CAPRICORN MUNICIPAL DEVELOPMENT GUIDELINES

2023 MEETING 4 MINUTES

Date and Time: 26th May at 11:00 am

W-090**W090A**

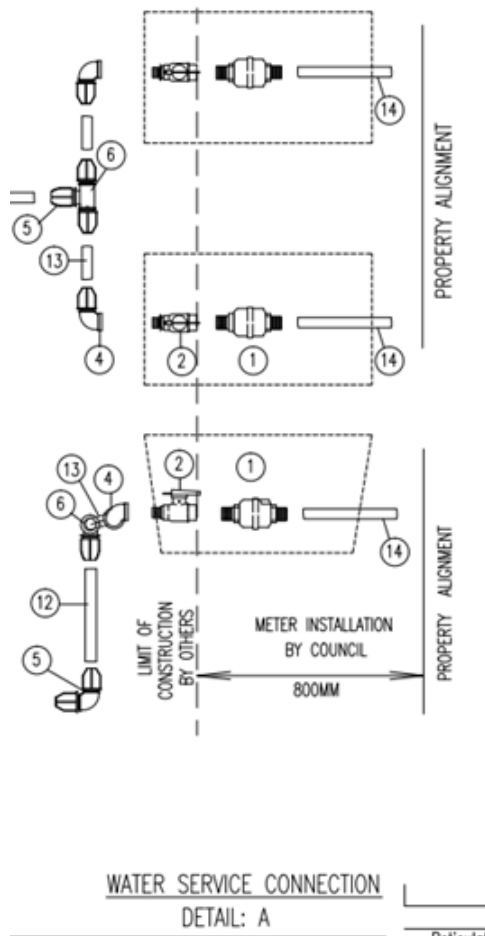
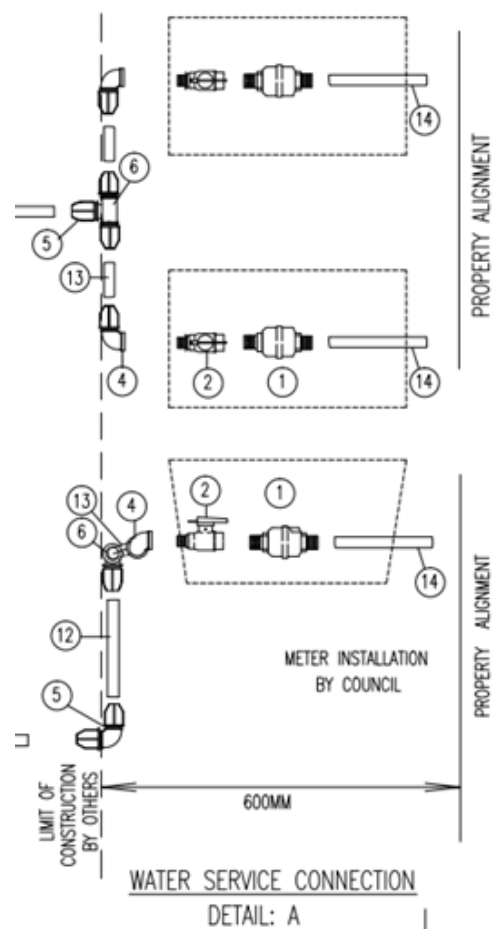
As part of an update to W-090 it was noted that the differences between W-090 and W-090A are minor and there may be an opportunity to combine them.

The key difference between the drawings W-090 and W-090A is the water service connection detail:

The other difference between the drawings is just the short single size on the W-090A is 25mm not 32mm, this could be covered in the applicability table if required.

The main benefit from not installing the valve is reduction in the risk of water theft.

Brief discussion on whether other LGA have experienced water theft. RRC noted that they (FRW) have had no issues. General agreement to maintain current practices. MRC noted no particular preference but would default to current arrangement unless general consensus to change.

Raised that GRC detail does not actually provide a connection to each individual property which may technically not comply with planning scheme.

GRC to confirm current installation practices with the potential to align with the other LGAs.

<p>MCE wait for response to GRC and depending on outcome investigate whether there is space to have both details on one drawing with a table of difference.</p> <p><u>Action By</u> GRC and MCE.</p>
M23.01.04	<p>D1 – Evacuation Routes</p> <p>It was raised by GRC that an evacuation route section/ clause may be beneficial in D1.</p> <p>A general clause may be useful referring to any specific work done by the relevant LGA on flooding/ storm surge to inform level and designated evacuation routes.</p> <p>An example from Mackay is reproduced below:</p> <p>2.19 Evacuation Routes</p> <p>Where works are proposed for existing or foreshadowed evacuation routes, designers shall recognise that minimisation of inundation during flooding or storm surge events is a requirement to ensure the ability of the roadway to maintain its function as an evacuation route.</p> <p>Crown levels on these roads is to be maintained at a minimum level of 5.0m AHD to ensure its viability and trafficability during evacuation incidents.</p> <p>Further, where the development is controlled by the storm surge Minimum Level of RL5.0m, then the road shall be no lower than 4.7m AHD at the lip of the kerb & channel.</p> <p>The evacuation routes to which this requirement applies are shown in the <i>Mackay City Council – Emergency Action Guide</i>. Copies of this document are available from Council and are on Council's web page.</p> <p>For discussion</p> <p><u>M2023.04 Discussion</u></p> <p>Discussion about the impacts from fires, there may be a requirement for multiple routes. Agreed not to include information/ requirement for fire as it is a broader planning topic and under the jurisdiction of QFES.</p> <p>Discussion about inclusion of road level information as it may be site specific and differs between LGAs/ locations and flooding mechanism. Consideration of including a version of paragraph 2 to refer back to LGA for specific level information. Agreed not to include as it is a given that developers would be liaising with LGA for levels.</p> <p><u>M2023.04 Resolution</u></p> <p>Add the first paragraph from the Mackay example to D1 with the title “Evacuation Routes – Flooding”</p> <p><u>Action By</u> MCE</p>
